**Amendments to the
Cascade Station/Portland
International Center Plan District**
Amendments to Title 33, Planning and Zoning

Ordinance No. 179076
Adopted February 17, 2005

**City of Portland
Bureau of Planning
1900 SW Fourth Avenue, Suite 4100
Portland, Oregon 97201-5350**

Figure 508-1014
Environmental Zone Subareas

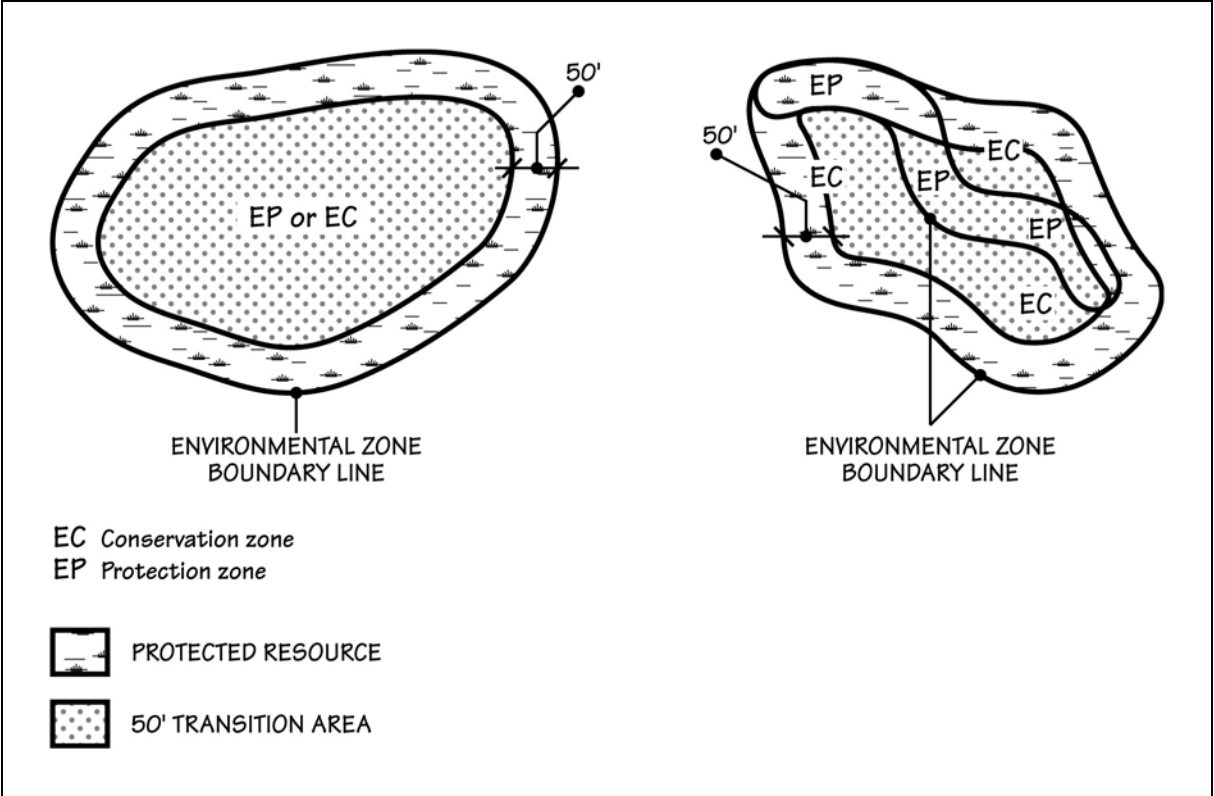
Figure 508-10 replaced with Figure 508-14 shown below

Section 4: Zoning Map Corrections

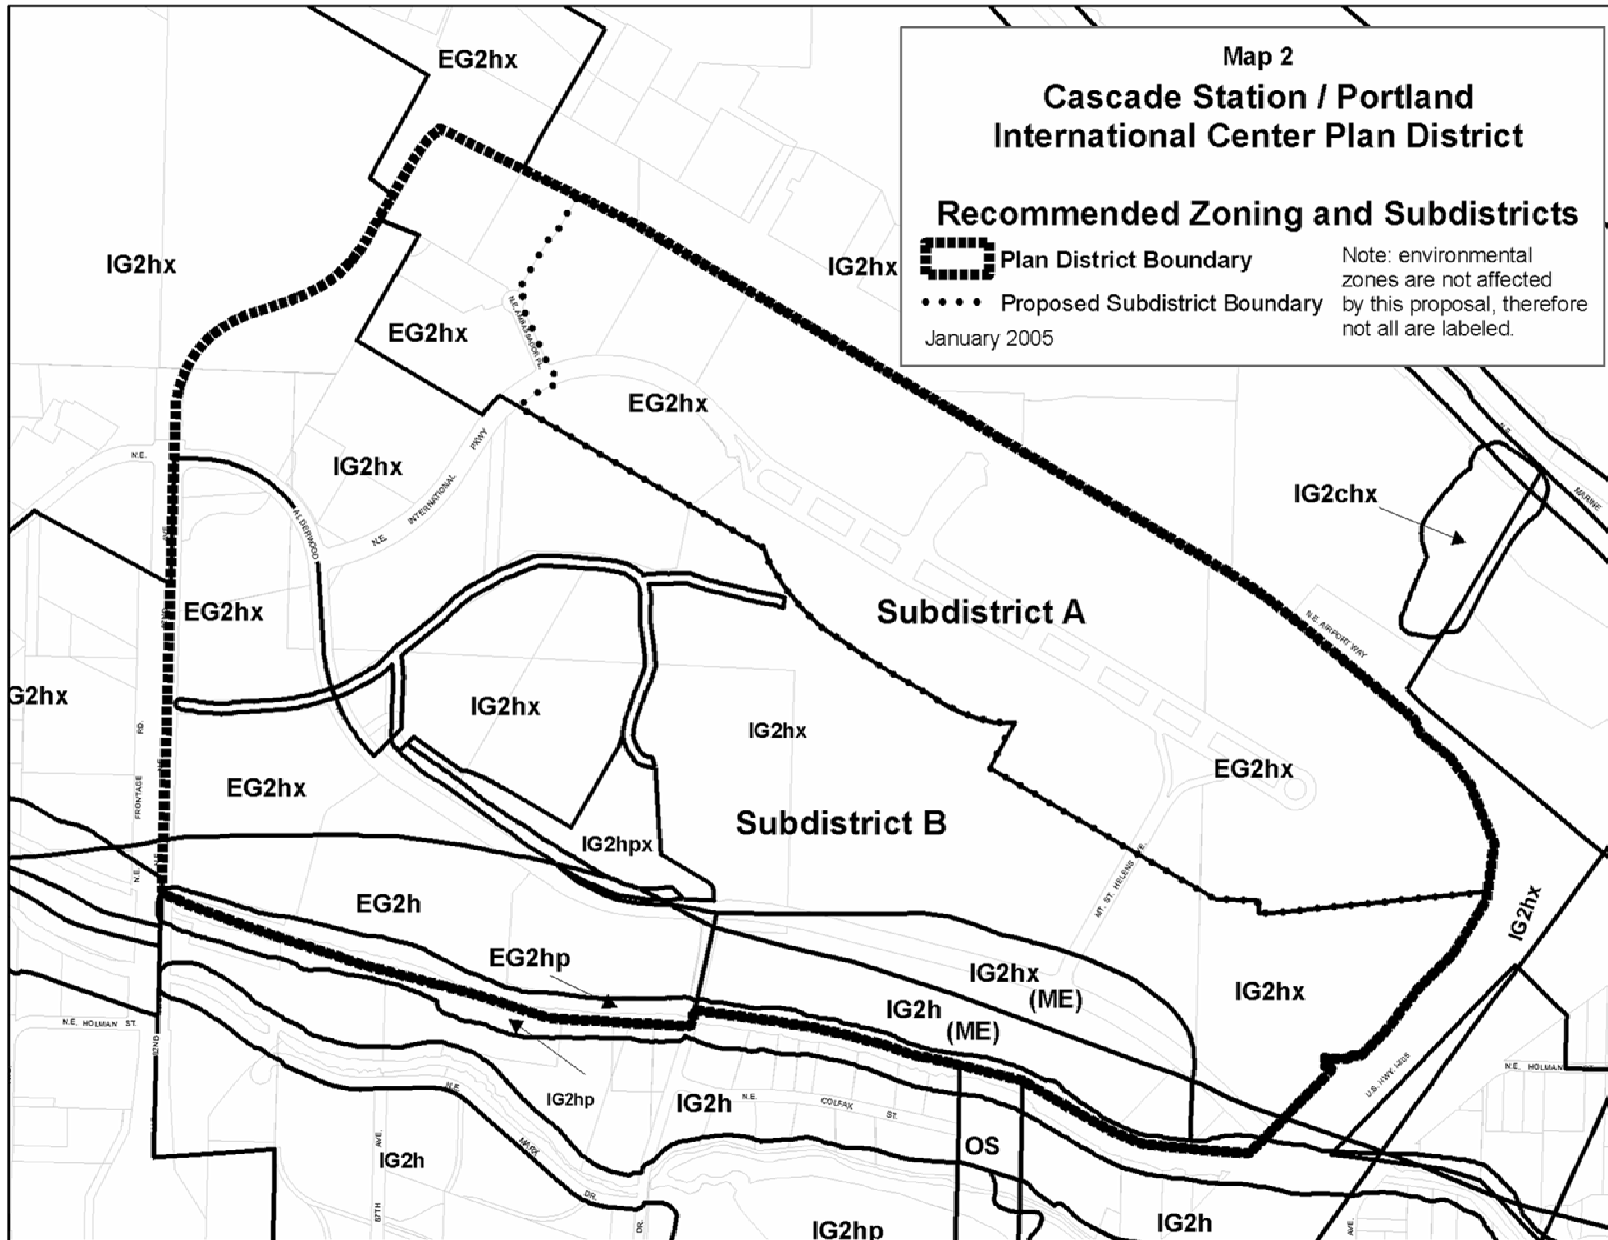
Section 4 of this report illustrates amendments to correct a mapping misalignment between base zone and plan district boundaries. A recent survey and legal

description for Subdistrict A was used to reconcile the zoning and plan district boundaries.

As stated in the introductory section of this report, Planning staff realized that base zone and plan district boundaries were not in alignment and that there were a few minor discrepancies with these delineations as represented on City GIS maps. Staff researched this issue with assistance from the Port of Portland, the owner of Cascade Station/PIC land. The Port provided Planning staff with a recent survey and legal description for Subdistrict A, which was used to reconcile the base zone and plan district overlay boundaries.
